Canadian Nuclear Laboratories Proposed Near Surface Disposal Facility (NSDF)

*Application to Amend the Licence to Construct
the NSDF at the Chalk River Laboratories (CRL) Site*

CNSC Staff Presentation

CMD 22-H7.C

NSDF Design

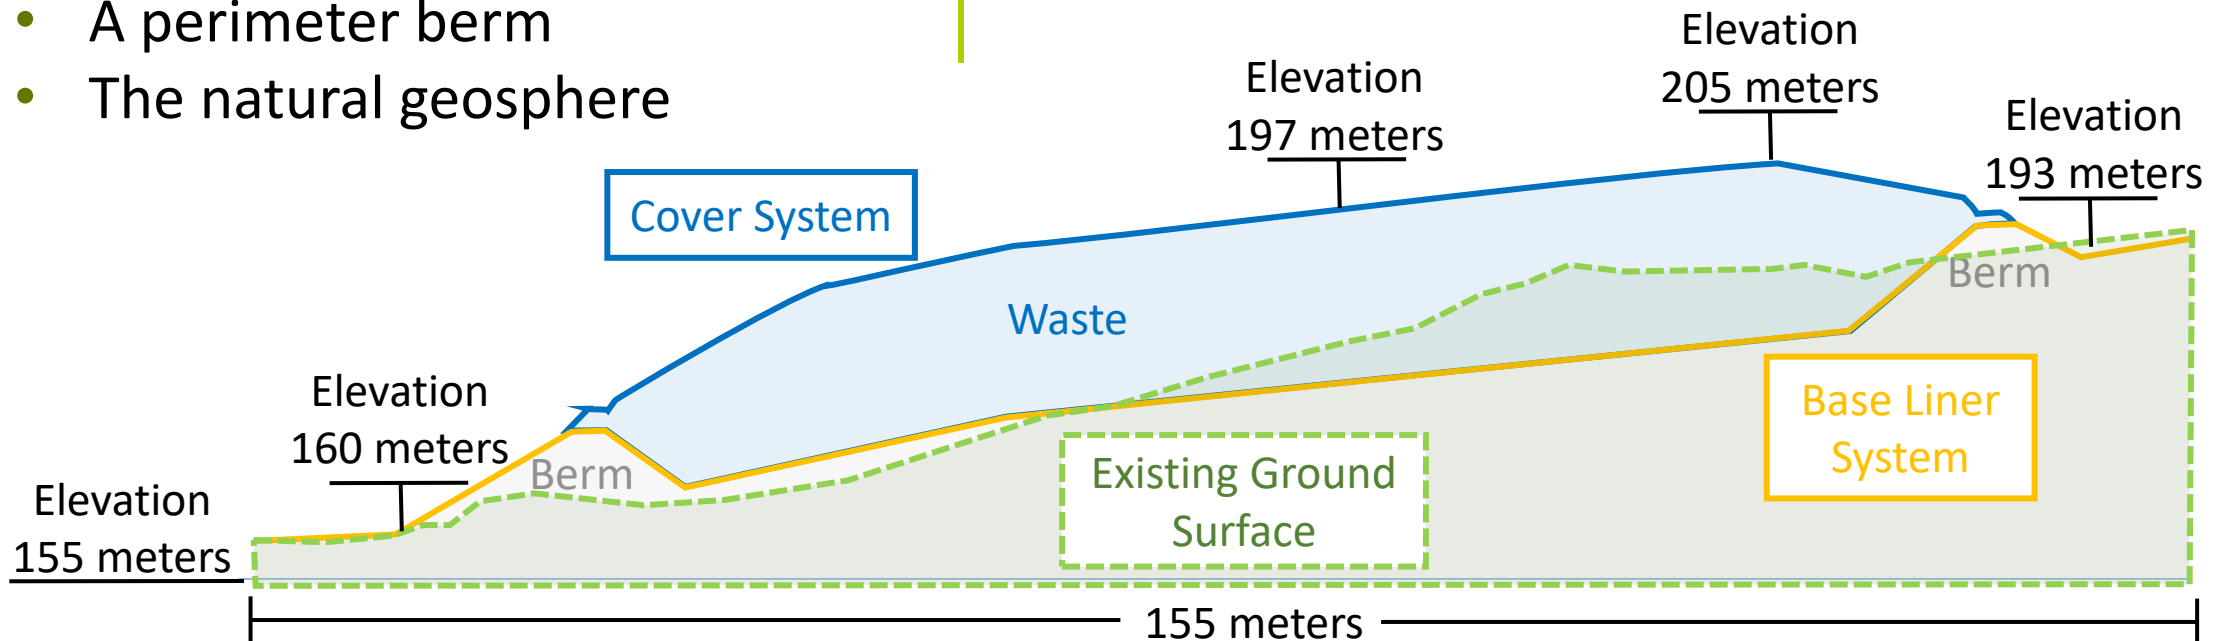
The design of the engineered containment mound complies with CNSC requirements and international standards

- Long-term safety is ensured by:
- A multi-layer base liner system
 - A multi-layer cover system
 - A perimeter berm
 - The natural geosphere

CNSC staff assessed that the engineered containment mound would meet or exceed its 550 year design life

Post-Closure Timeframe Assessment

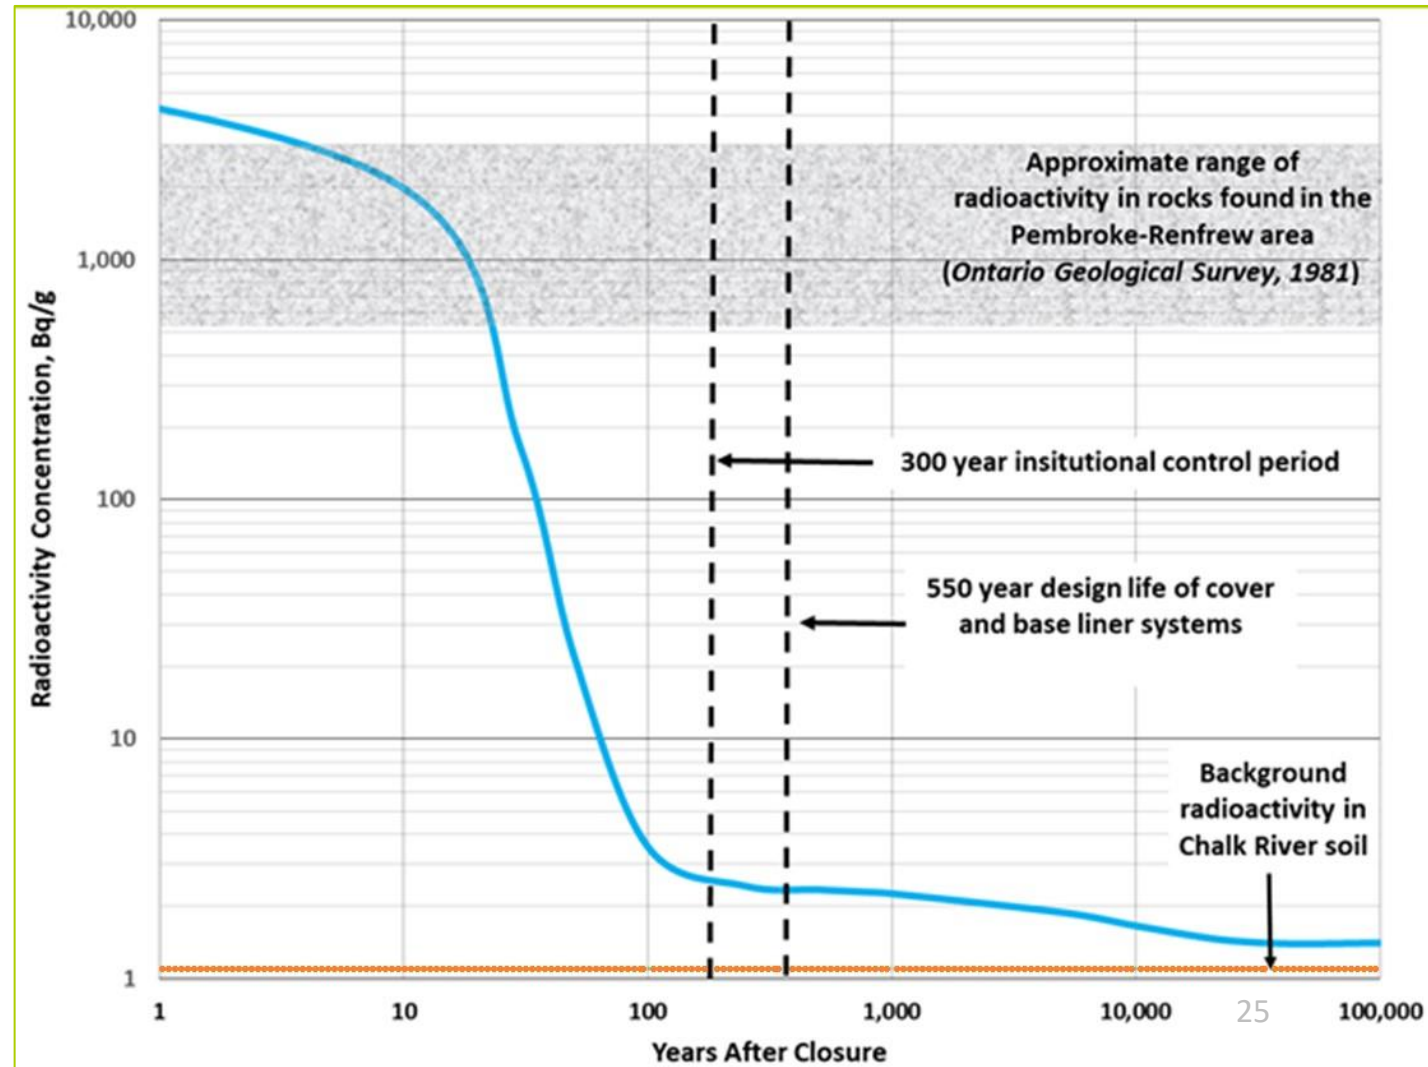
- At 300 years the majority (99%) of the NSDF inventory would have decayed to near background levels
- Evidence supports timeframes for institutional control (300 years) and barrier design life (550 years)
